Town of Hilton Head Island
**TOWN COUNCIL TOWN COUNCIL
WORKSHOP MEETING**
Tuesday, April 5, 2022
1:00 - 2:45 p.m.
AGENDA

ITEM TITLE:
Recommend Approval of a resolution of Beaufort County Responses to Town of Hilton Head comments on the US 278 corridor traffic improvement project
MEETING NAME AND DATE:
March 28, 2022 County Council
PRESENTER INFORMATION:
Jared Fralix, Assistant County Administrator 5 minutes

**BEAUFORT COUNTY RESPONSES TO TOWN OF HILTON HEAD COMMENTS ON
THE US 278 CORRIDOR TRAFFIC IMPROVEMENTS PROJECT**

Responses to MKSK Recommendations

Appendix 1: Jenkins Island Meandering

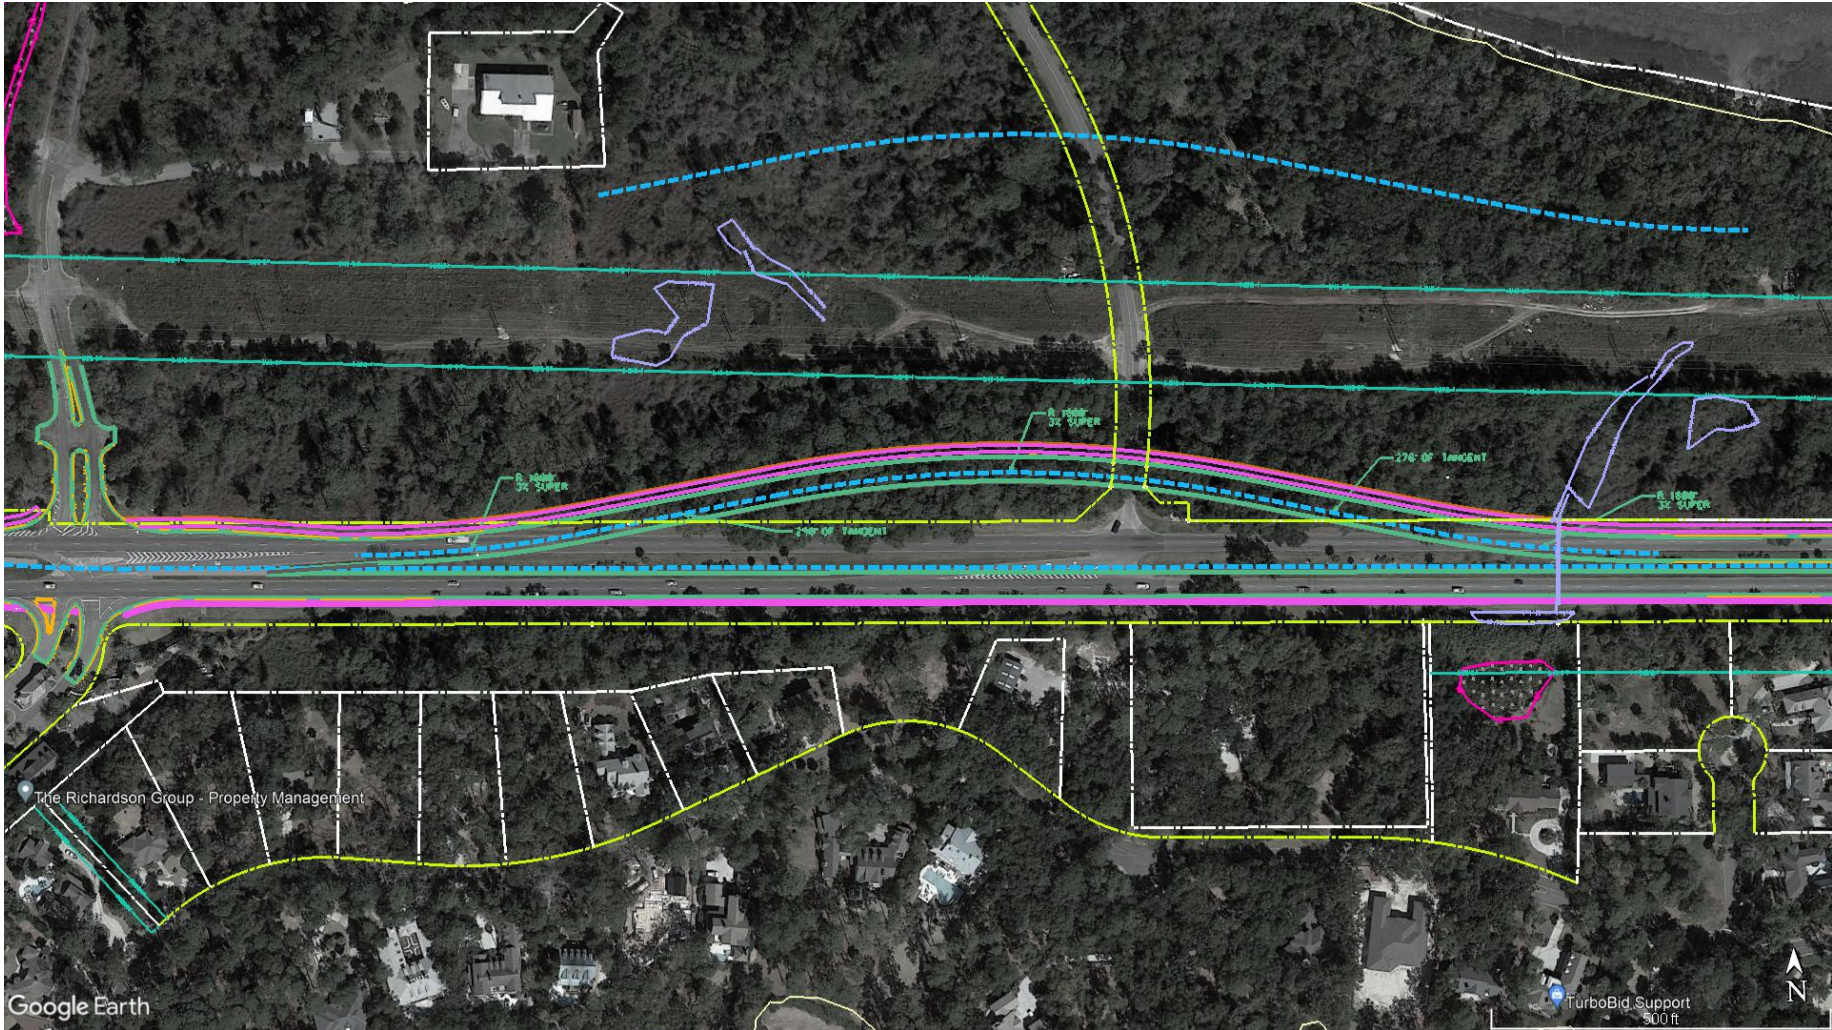
3. Vary median widths and meander roadway alignments where possible for traffic calming and aesthetics

Preliminary Response: Agreement on varying median through Jenkins Island, holding eastbound lanes in the existing alignment and moving westbound travel lanes North on Jenkins Island between Crosstree Drive and the causeway. The costs are to be estimated and if project overrun will need to be funded locally (not SCDOT or SIB funding).

Additional Response: The meandering of the roadway is estimated to increase project cost by approximately \$1.5M and was designed to avoid all critical area and freshwater wetlands. Additionally, the meandering of the roadway would not be permitted to result in wetland impacts greater than the Recommended Preferred Alternative 4A, as presented at the Public Hearing. Appendix 1 shows the proposed layout of the meandering on Jenkins Island that avoids critical area

wetlands and freshwater wetlands. The additional cost does not include any costs for the additional Town-owned ROW required to meander the roadway and the ROW is assumed to be donated. The County does not have extra funds for an additional cost, and additional local funds would need to be identified early in the design process by the Town.

Figure 1 - Lane Geometries and LOS – Preferred Alternative 4A

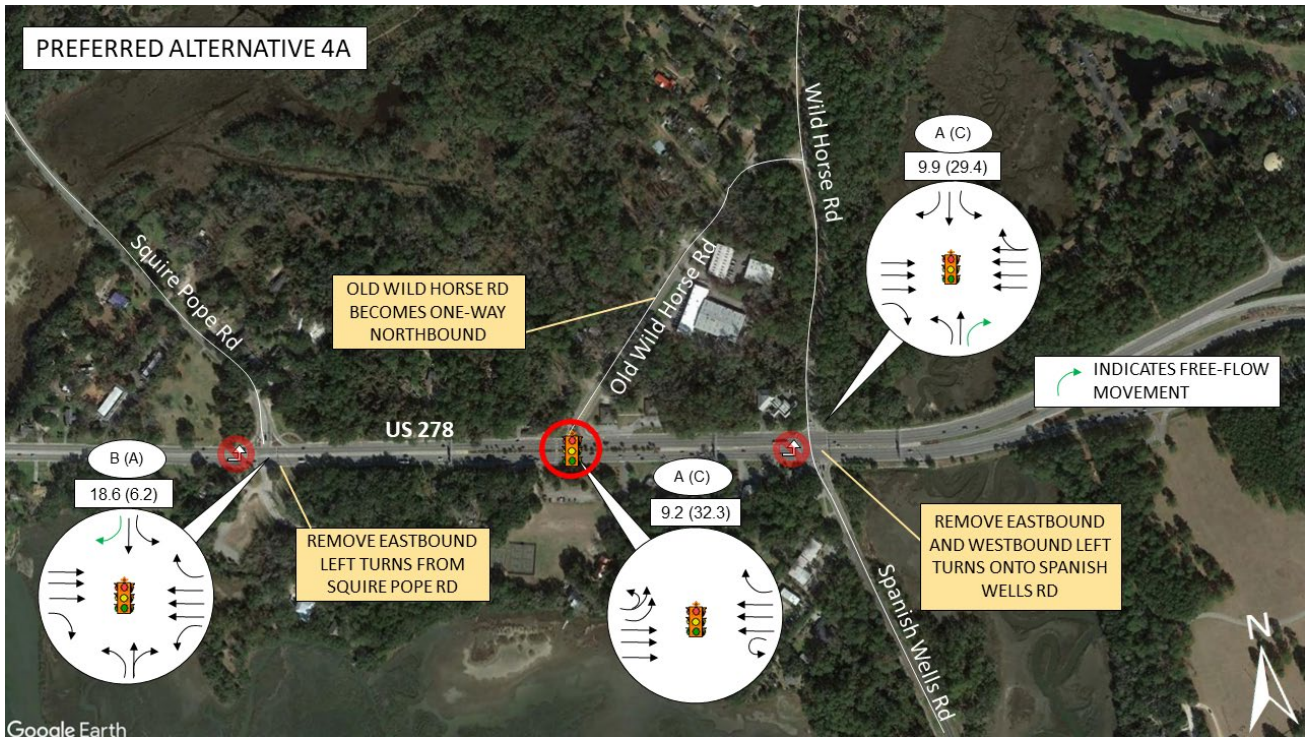
The Town of Hilton Head’s land planning consultant, MKSK, and HDR have requested additional intersection analysis along US 278. The additional analysis includes reinstating the left turn lanes at Squire Pope Road and Spanish Wells Road. This technical memorandum details the future year 2045 operational analysis for the two new alternative scenarios and how they compare to the preferred alternative presented at the US 278 Public Hearing on July 22, 2021.

The preferred alternative presented at the Public Hearing proposed to remove the eastbound left turn lane from US 278 onto Squire Pope Road, remove the eastbound and westbound left turn lanes onto Wild Horse Road and Spanish Wells Road, and to add a signal at Old Wild Horse Road to facilitate u-turn movements. This configuration of two- and three-phased signalized intersections will work together as a system to help improve the overall intersection operations along this segment of US 278. The lane geometries and levels of service (LOS) are provided in **Figure 1**.

The recommended preferred alternative presented at the US 278 Public Hearing on July 22, 2021, provides the best signal operations for the intersections of Squire Pope Road and Spanish Wells Road. This alternative also provides the shortest travel time between the intersections during the AM and PM peak hours in the eastbound direction and during the PM peak hour in the westbound direction. However, it should be noted that this traffic analysis only compares the alternatives based on signal operations and travel time analyses. Although the preferred alternative performs the best, there is minimal discernment that is obtained between these three alternatives.

Upon considering other factors that include quantifying impacts to Traditional Cultural Property (TCP) and evaluating local government input and public comments received during the public hearing, it is apparent that Option 1 provides a better balance between the need for traffic performance within the corridor and sideroads, while minimizing the TCP impacts throughout the Stoney Community. Furthermore, Option 1 reduces TCP impacts to the three parcels located on the north side of US 278 between the causeway and Squire Pope Road as compared with the recommended preferred alternative and Option 2.

Figure 2 - Lane Geometries and LOS – Option 1

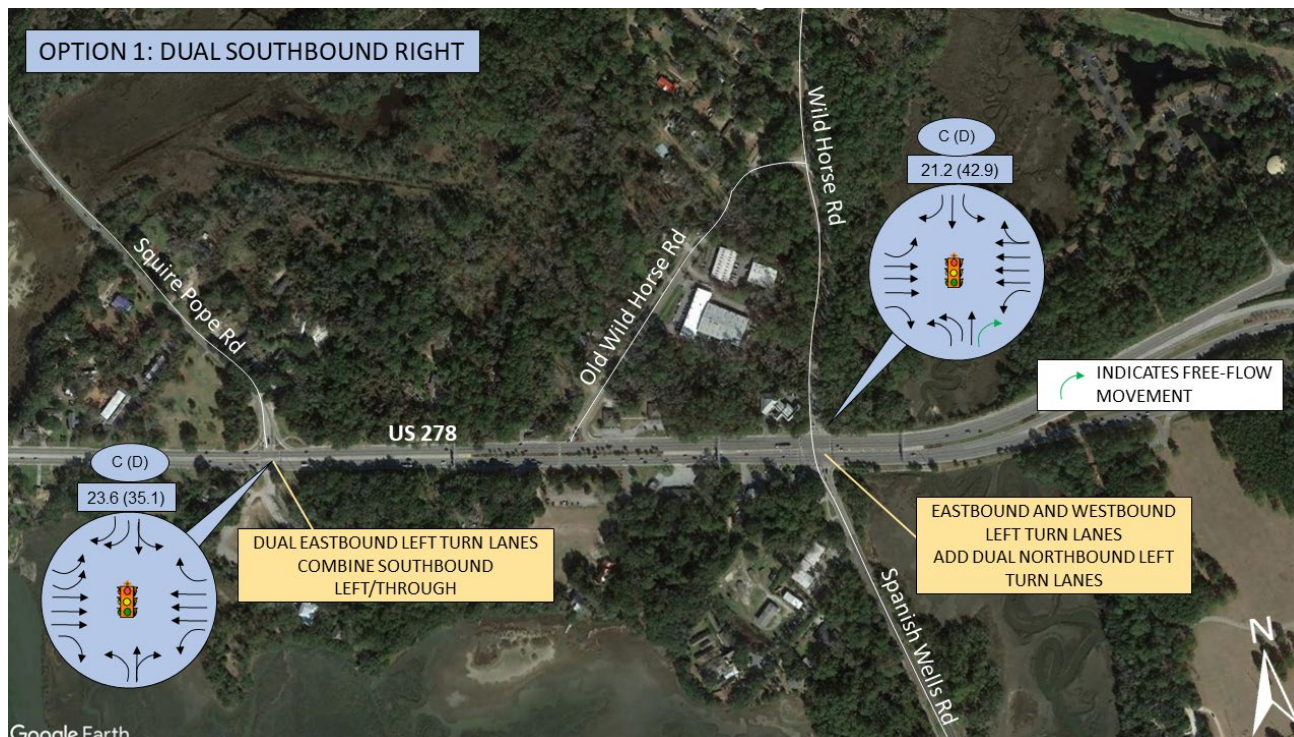
Figure 2 shows the lane geometries and LOS results for Option 1. **Table 3** summarizes the operational analysis of the intersections. In the AM peak hour, Squire Pope Road and Spanish Wells Road operate at LOS C. In the PM peak hour, both intersections operate at LOS D.

The SimTraffic results, provided in **Table 4**, show an arterial speed of 20 mph in the eastbound direction and 34 mph in the westbound direction during the AM peak hour, with a total travel time of 70.6 seconds in the eastbound direction and 42 seconds in the westbound direction. In the PM peak hour, the arterial speed is 23 mph in the eastbound and westbound directions with a total travel time of 63 seconds in the eastbound direction and 63.8 seconds in the westbound direction. The Synchro and SimTraffic reports are provided in **Appendix B** and **Appendix C**, respectively.

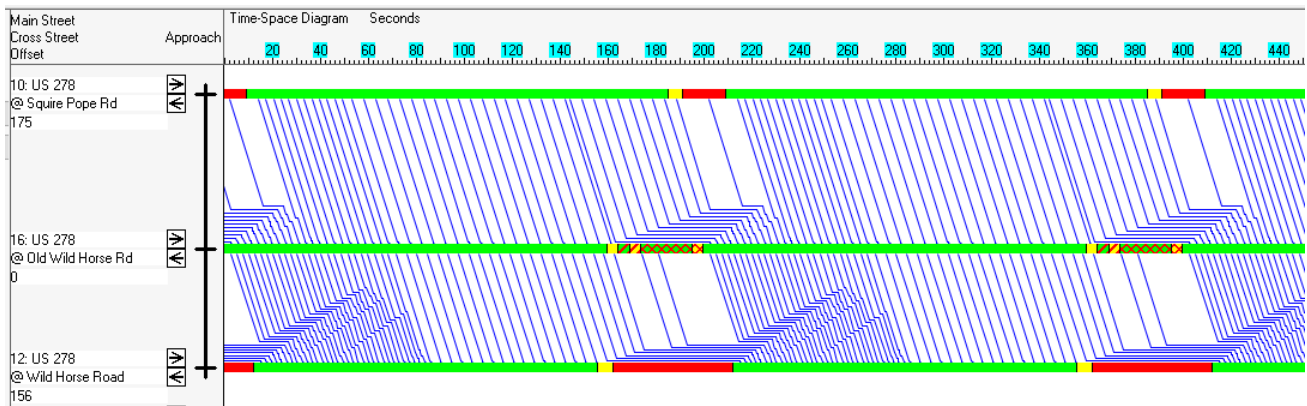
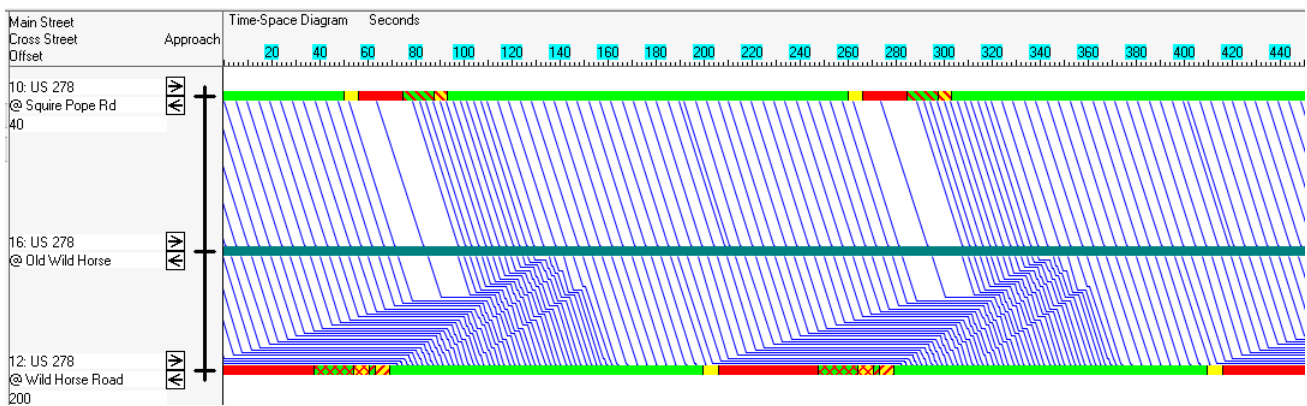
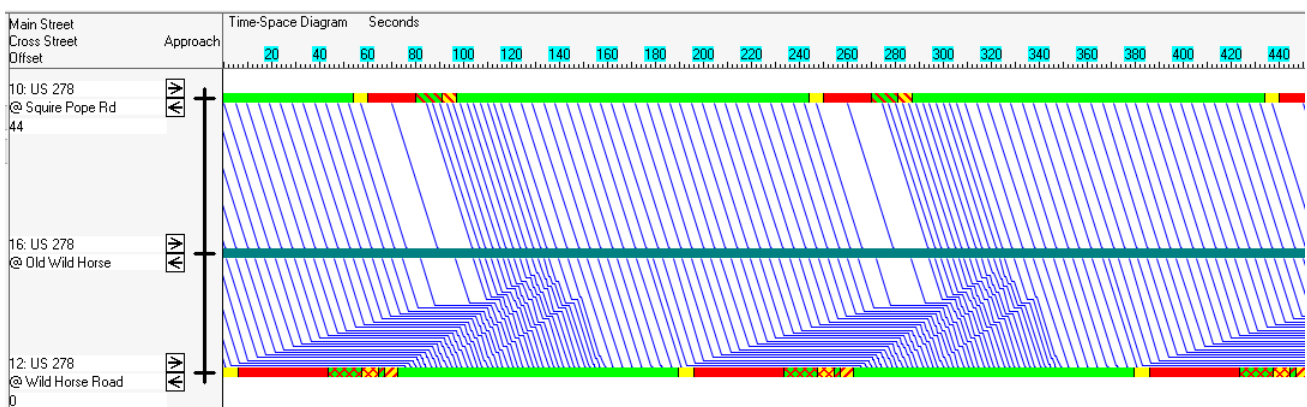
Figure 5 shows the PM peak hour eastbound progression for the preferred alternative. The width of straight lines is approximately 70 seconds. Some vehicles will get stopped at the Old Wild Horse Road signal to allow for the protected u-turn movement phase, indicated by the hatched areas in the green horizontal line. However, because the signals are coordinated and consist of two- and three-phases, once the eastbound traffic gets a green, the queues dissipate at Spanish Wells Road and vehicles can travel unimpeded for 70 seconds.

Figure 6 shows the eastbound progression for Option 1. **Figure 7** shows the eastbound progression for Option 2. When compared to the preferred alternative, these alternatives show a much longer queue at Spanish Wells Road. Vehicles begin stacking when the eastbound direction receives a red light. When the light turns green, the front of the queue begins to dissipate, but the back of the queue does not flush out until halfway through the green phase. Although the signals at Squire Pope Road and Spanish Wells Road are also coordinated, they are both four-phase signals that require protected phasing for eastbound and westbound left turns from US 278 (as indicated by the hatched areas within the green horizontal line), which take away from the green time for through traffic along US 278.

In the eastbound direction during the PM peak hour, Options 1 and 2 have an unimpeded time of approximately 35 and 30 seconds, respectively. This indicates that although there is some delay encountered with the additional signal at Old Wild Horse Road, the overall progression of through traffic is better in the preferred alternative.

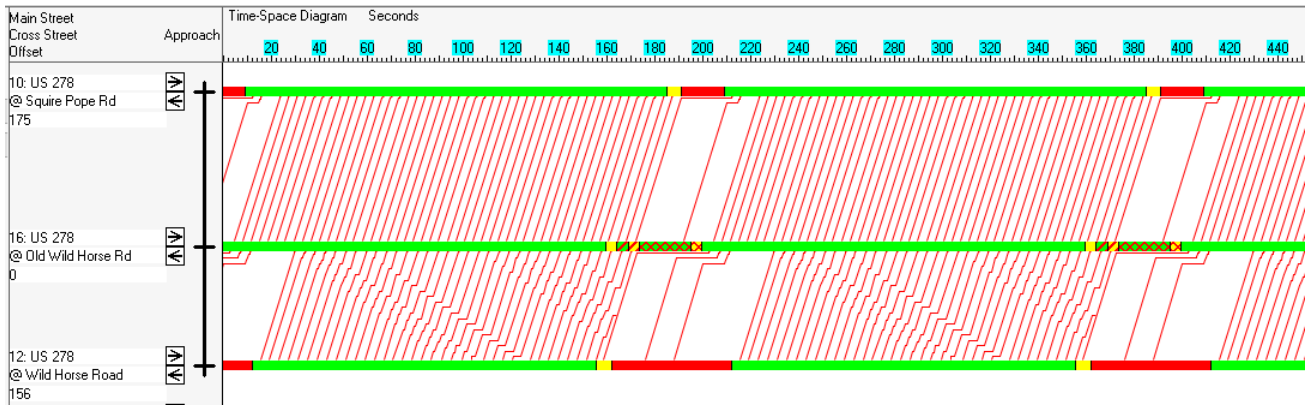
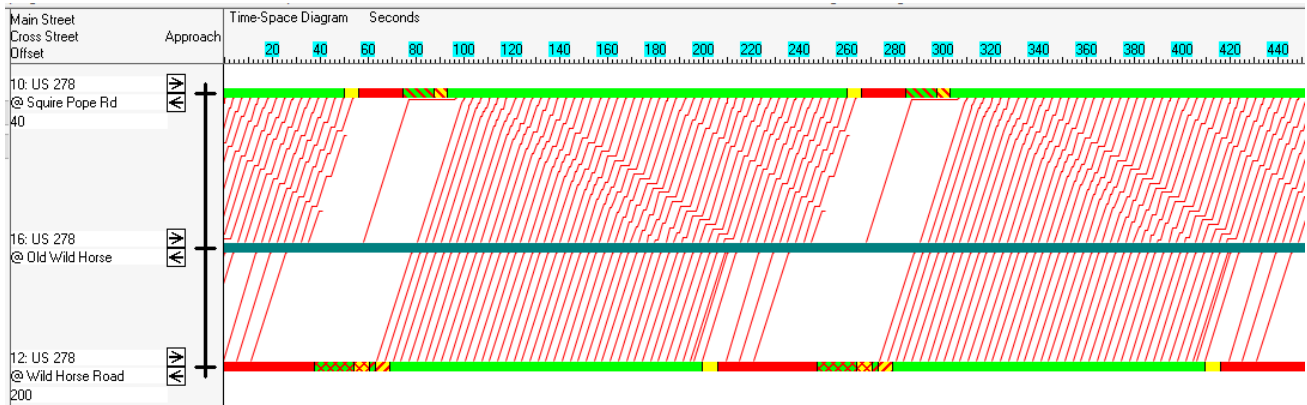
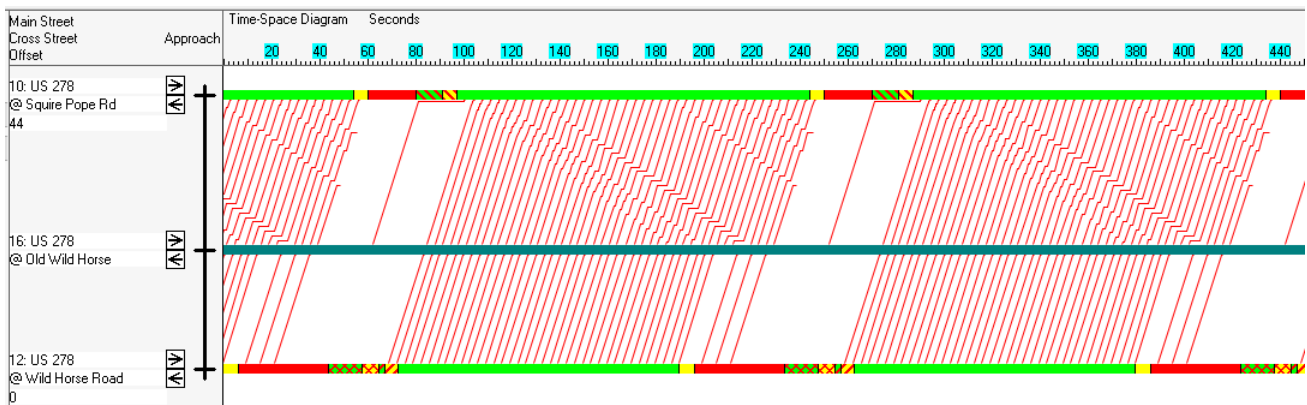
Figures 8-10 show the time-space diagrams for the PM westbound direction. It is often difficult to achieve progression in both directions along a corridor within the same time period. During the PM peak hour, westbound is the peak direction and therefore the signal coordination is optimized in this direction. The progression in the westbound direction in the PM peak hour is essentially the same for all three alternatives.
